We thank the editor and referees for the encouraging comments and suggestions to improve the manuscript. We believe that the revised manuscript is substantially improved particularly in detailing the technical aspects of the modelling and input data; discussing soil depth and soil data considerations. The improvements made to the entire revised article are summarised below.

Referee 1

Figure 7: Timeseries of basin average rainfall (filled line plot) and changes in ET (in mm/day; lines) with inclusion of lateral flow in the Upper, Ovens, and Murray Riverina Basins.

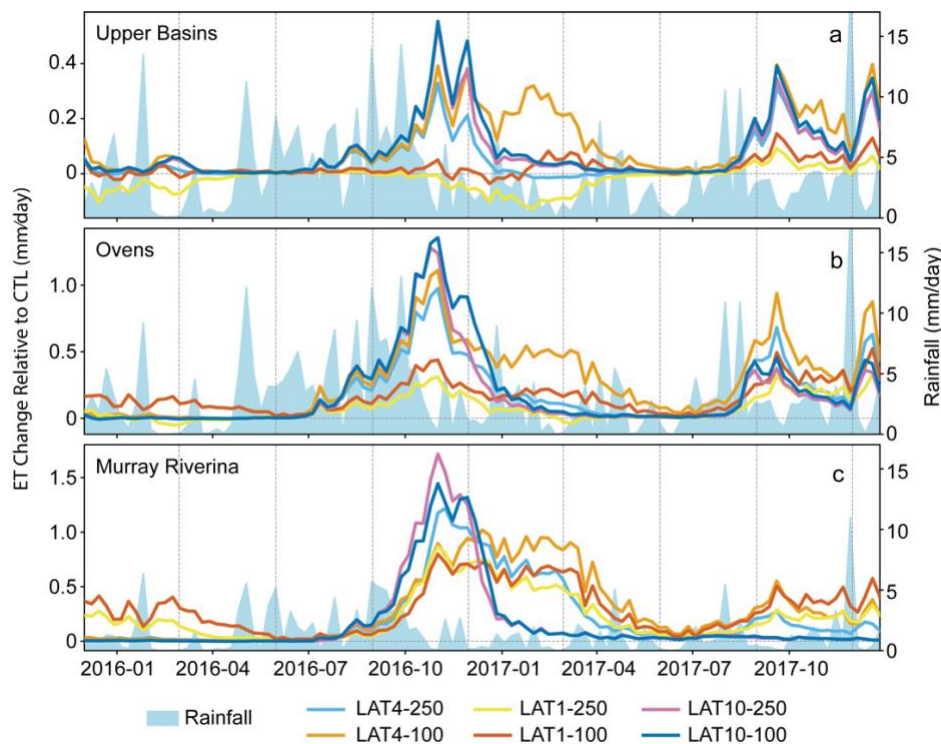
4. **Figure 7: Please add a ET Change Relative to CTL label on the y axis. Also please ensure the labels are all correct (CTL1-250 doesn't exist in this study).**

We thank the referee for the comment on Figure 7, and for noting the error in the legend. We have addressed these in the revised version of Figure 7 shown below.
